SUBDIVISION COMMITTEE  
METROPOLITAN AREA PLANNING COMMISSION

STAFF REPORT  
(Final Plat, Preliminary Approved 3/19/92)

CASE NUMBER: S/D 92-47 - LAKE RIDGE 2ND ADDITION

VICINITY MAP:

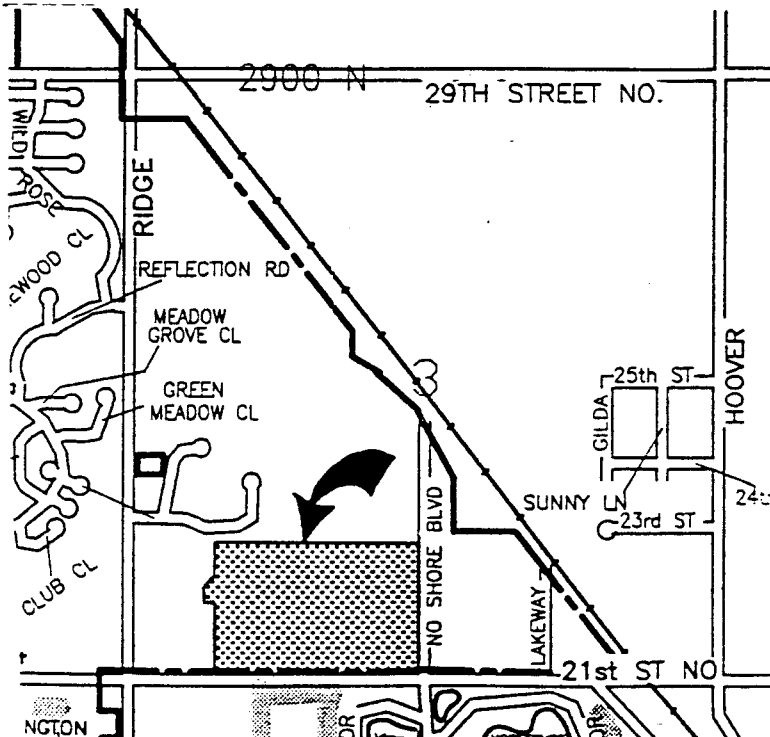
- L. The reserve in the cul-de-sac adjacent to lots 1, 2, & 3, Block 1 is not apparently labeled, e.g., Reserve I. On the final plat tracing this Reserve shall be property labeled on the face of the plat and described in the plat's text.

- N. As noted from the preliminary plat, the applicant was proposing to relocate the ARKLA pipeline easement existing on this property. This would require the releasing of the existing pipeline easement and the granting of a new easement adjacent to this subdivision. However, this plat appears to be indicating

2. Any relocation, lowering or encasement of the pipeline, made necessary by this development, will not be at the expense of the City.
  3. Additional dimensions should be indicated on lots 1 & 2, Block 1 to better locate the pipeline easement.

- O. The ARKLA pipeline as is now being shown, significantly encumbers lots 1 & 2, Block 1. In particular, it appears that unless the pipeline is relocated, that lot 2 is not an acceptable building site. The applicant shall therefore submit for recording with this plat, a covenant indicating that lot 2 cannot be developed for a habital structure until the existing pipeline is relocated and/or the present pipeline easement is released or reduced sufficiently.
